**PLANNING COMMISSION
MEETING AGENDA
REGULAR MEETING**

5. PRELIMINARY SITE PLAN APPROVAL – (SP JPLN2025-0001) – Proposed GFA Forsyth Site Condominium, 9 single family detached units, North of Wattles, West of Dequindre (4189 and 4197 Forsyth; PIN 88-20-13-401-028, -037 & -038), Section 13, Presently zoned R-1C One Family Residential Zoning District.

Preliminary Site Condominium Review For City of Troy, Michigan

Project Name:	GFA- Forsyth
Applicant:	Gary Abitheira
Plan Date:	April 30, 2025
Location:	4165, 4189, & 4197 Forsyth Drive
Zoning:	R-1C, One-Family Residential District
Action Requested:	Preliminary Site Plan Review

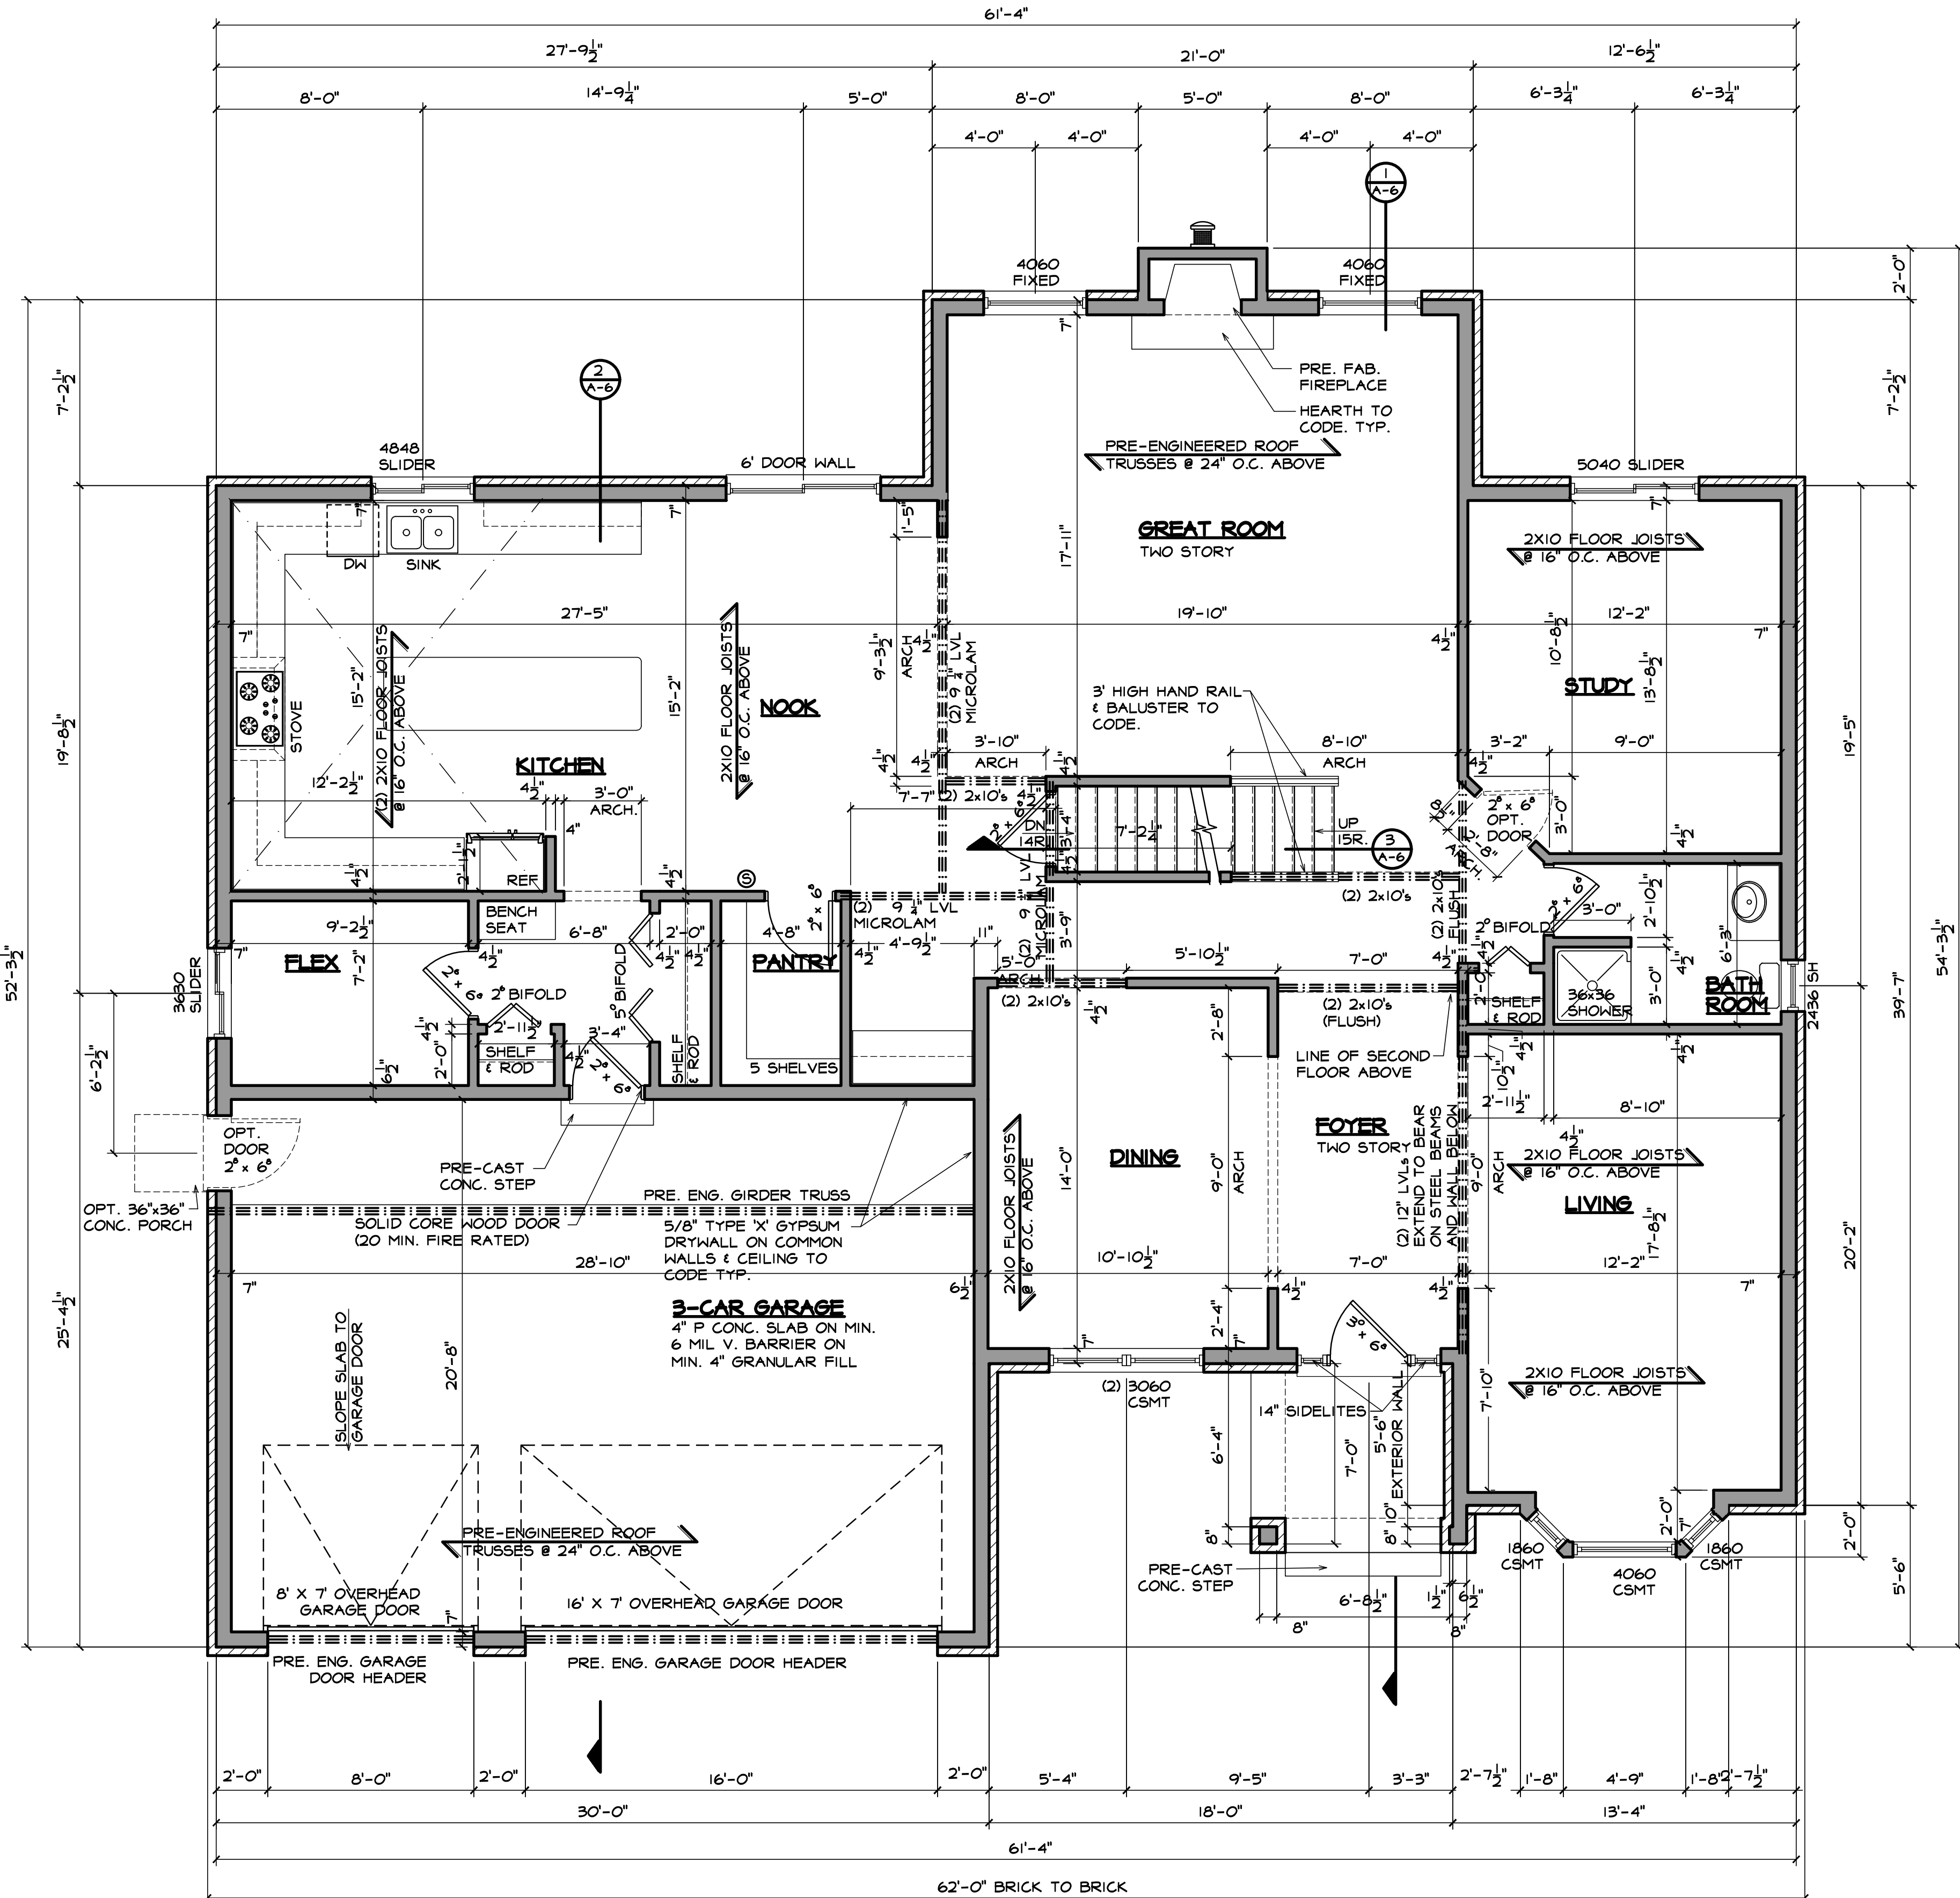
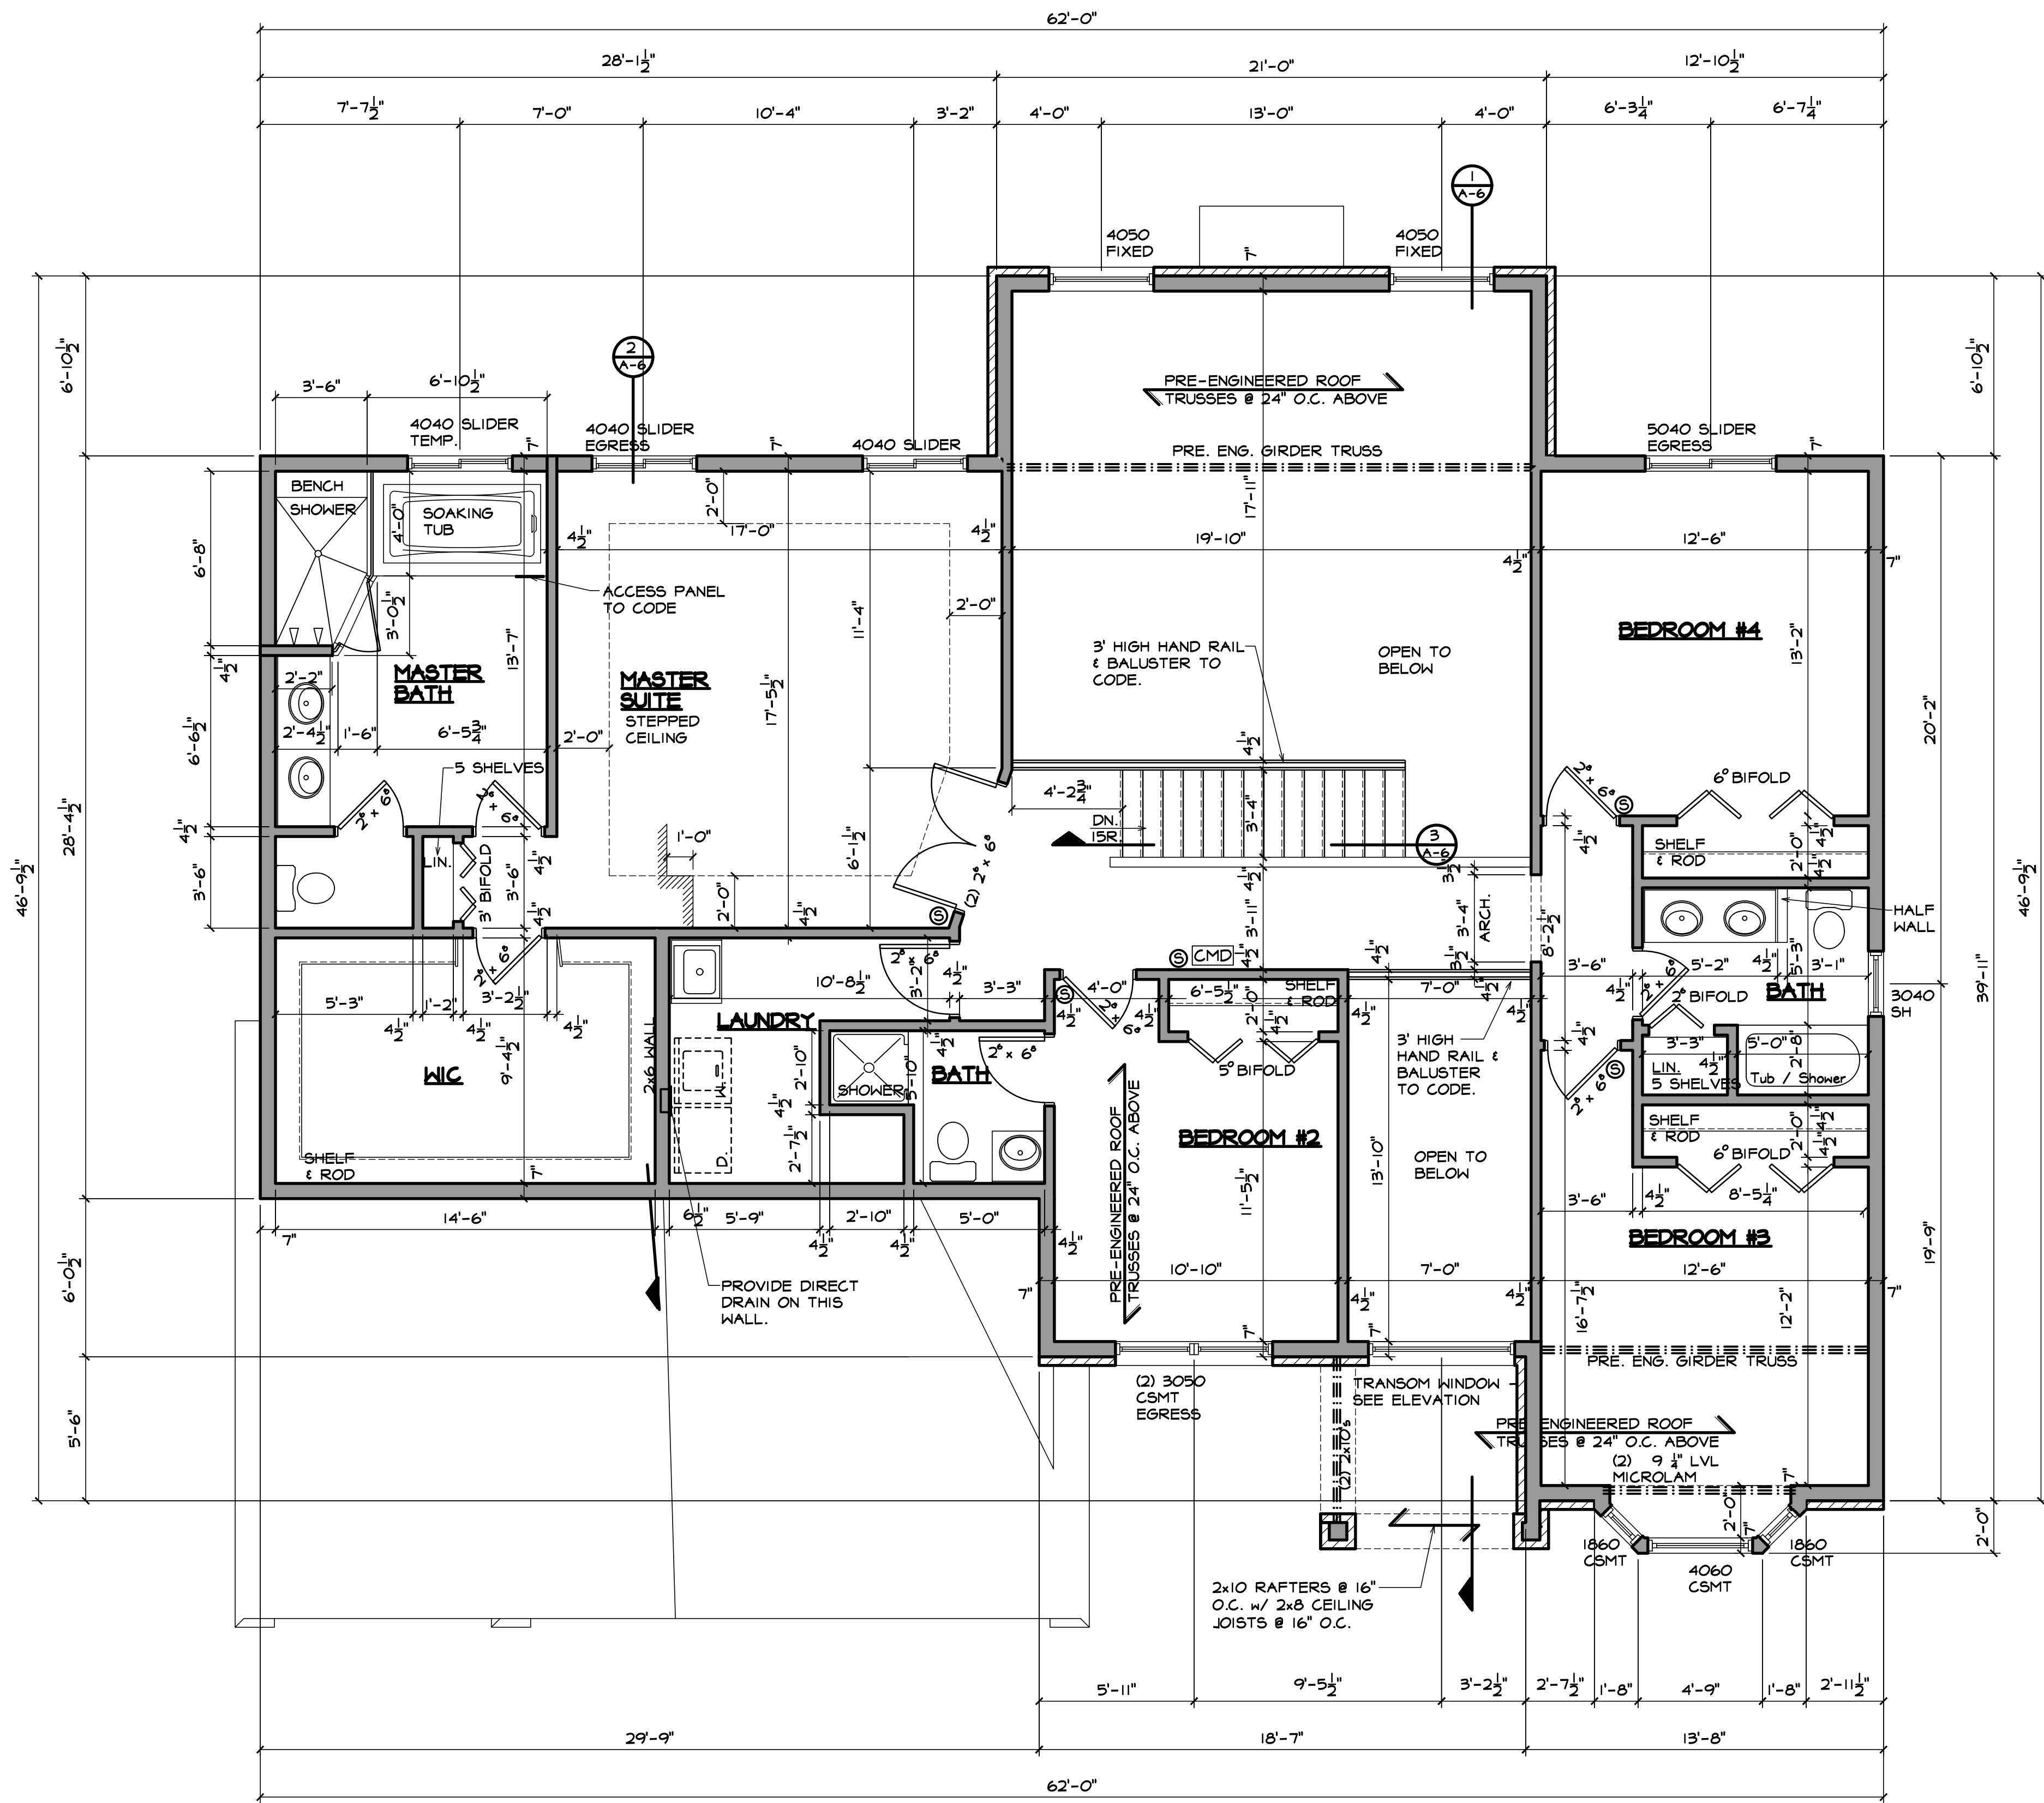
The applicant has provided floor plans and elevations for two (2) housing types, referred to as “The Troywood” and “Vanderpool.”

Both housing types contain a 3-car garage, four (4) bedrooms, and four (4) restrooms. Site plans show the area of the Troywood as 3,549 square feet, however the area of the Vanderpool is not indicated.
